Re: **Huntington Beach Generation Station Retool Project, Unit 3 and 4**  
**Docket No. 00-AFC-13C**

**PETITION TO AMEND FINAL DECISION TO CONVERT GENERATING UNITS TO  
SYNCHRONOUS CONDENSERS**

# HBGS Units 3 and 4 Synchronous Condenser Supplemental Analysis

**FIGURE 1**  
**General Arrangement**  
 Synchronous Condenser Project  
 HBGS 3 and 4  
 Huntington Beach, California

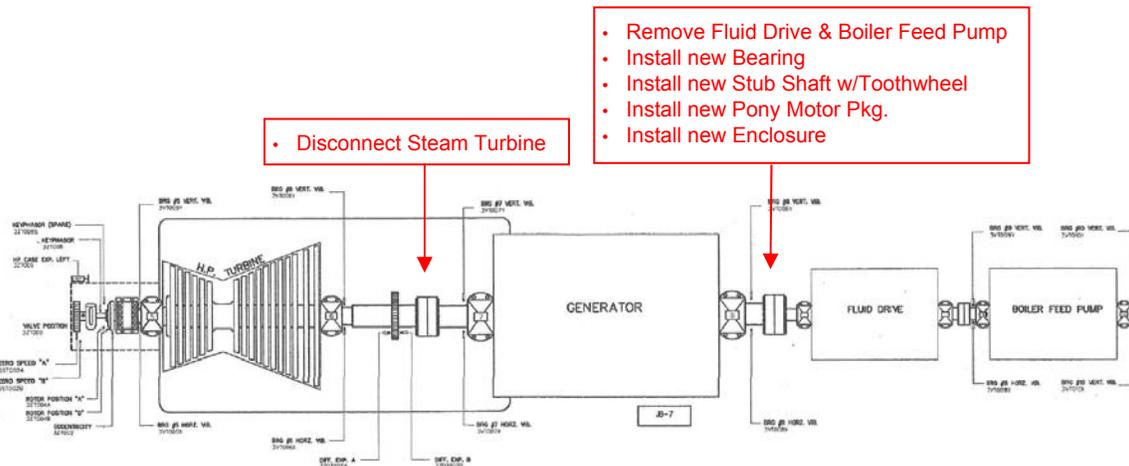
The HBGS Units 3 and 4 generators are located on the steam turbine deck as shown on Figure 1. The pony motors will be located on the turbine deck adjacent to the generators. The pony motor will connect to the steam turbine generator shafts via a new stub shaft, bearing and coupling. The steam turbines will be decoupled from the generators. Figures 2 and 3 present the plan and elevation schematics of the connection of the pony motors to the generator shafts. Units 3 and 4 will be retired and rendered inoperable to satisfy, in part; the emission offset requirements contained in condition of certification AQ-19 of the Final Commission Decision for the Walnut Creek Energy Park (CEC Docket No. 05-AFC-2). The existing steam turbine generator lubricating oil systems will be modified to provide lubricating oil to the pony motors thrust bearings and lubricating pumps will be included as needed. The pony motors will be contained in weather tight enclosures.
